7 July 1961

TO  
FROMSubject: ECP LAC-112 - "INSTALL LARGER RELAY & CIRCUIT  
BREAKER BOX"

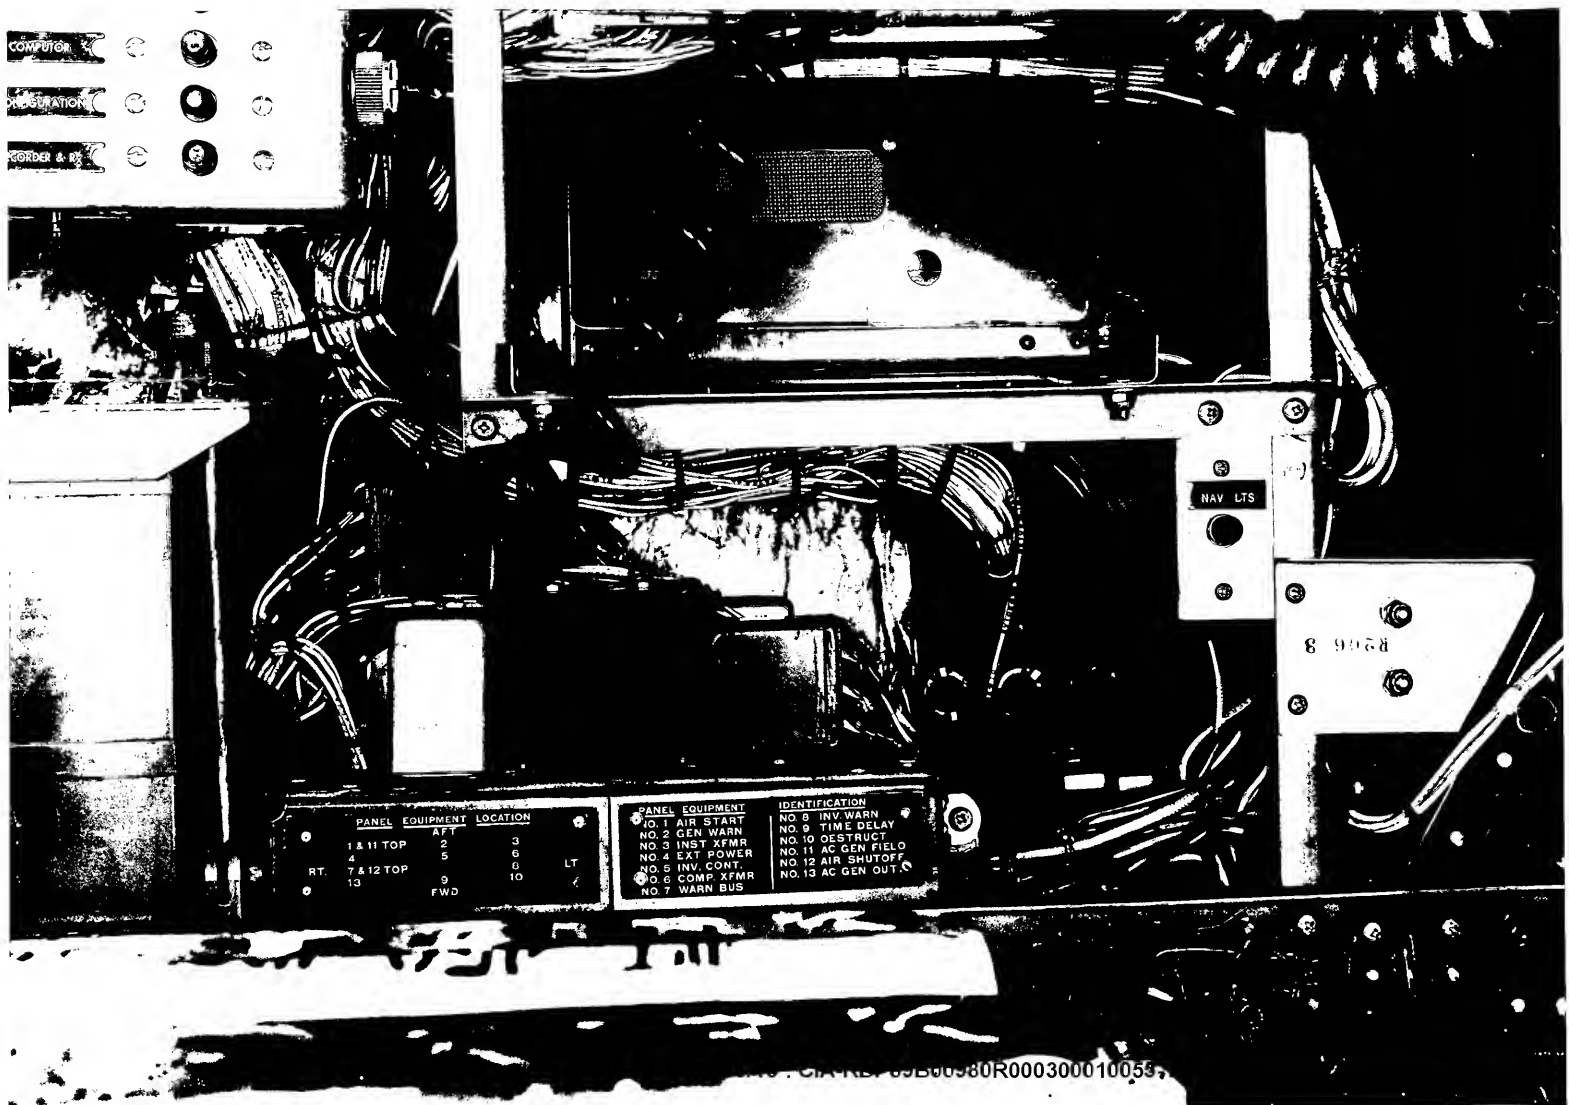
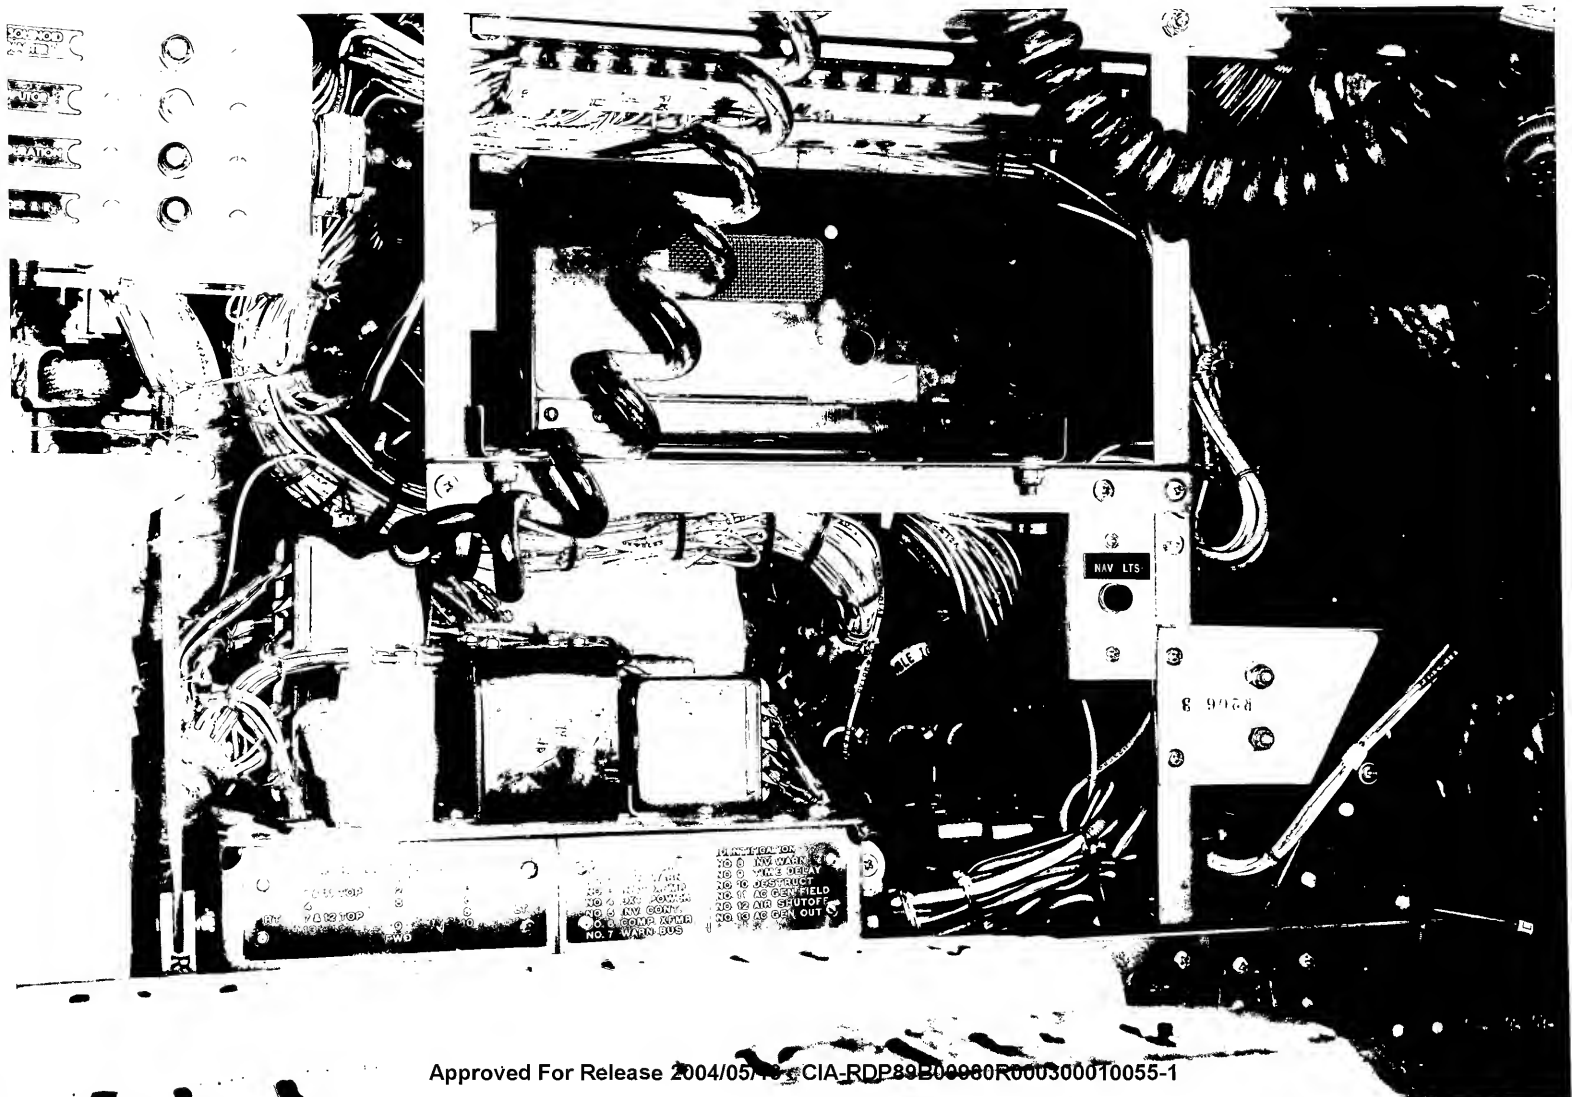
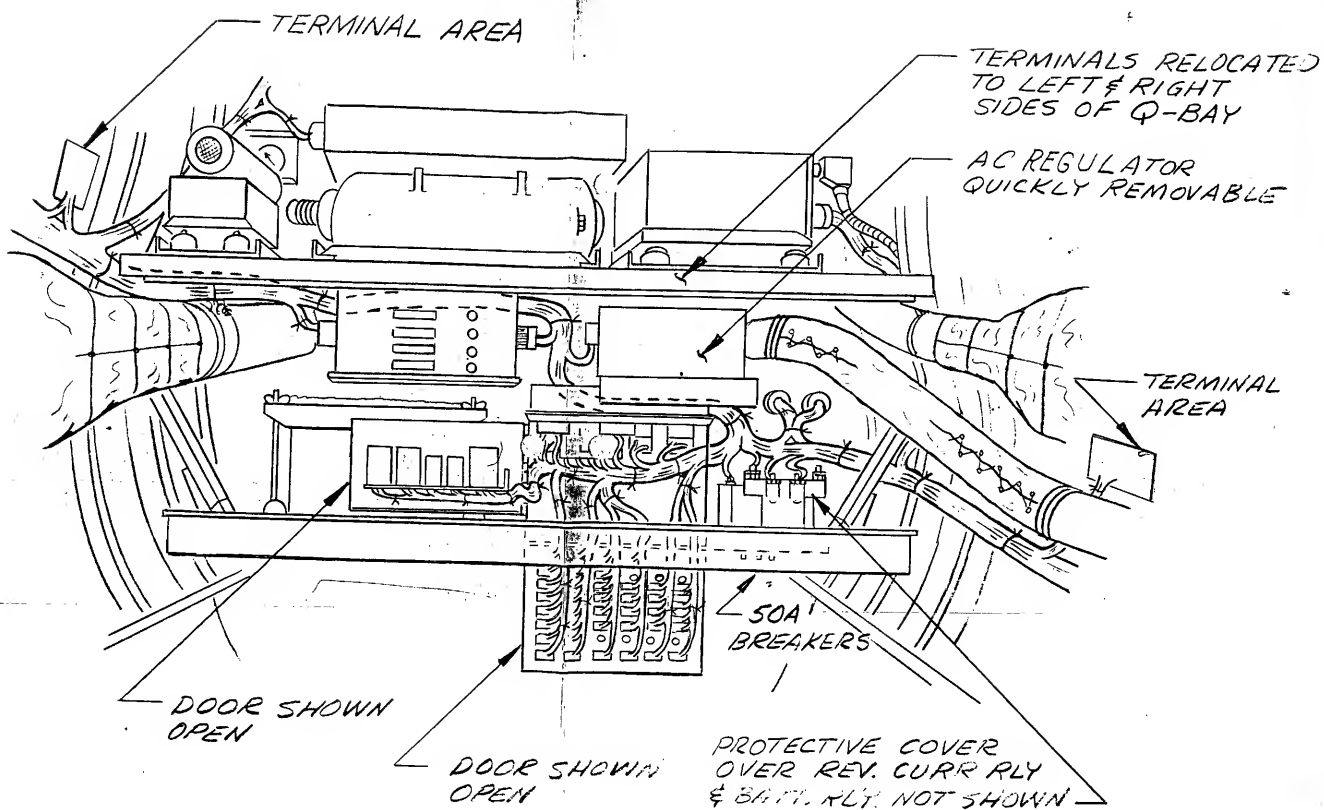
The enclosed photos delineate the present configuration and the drawings are of the new configuration.
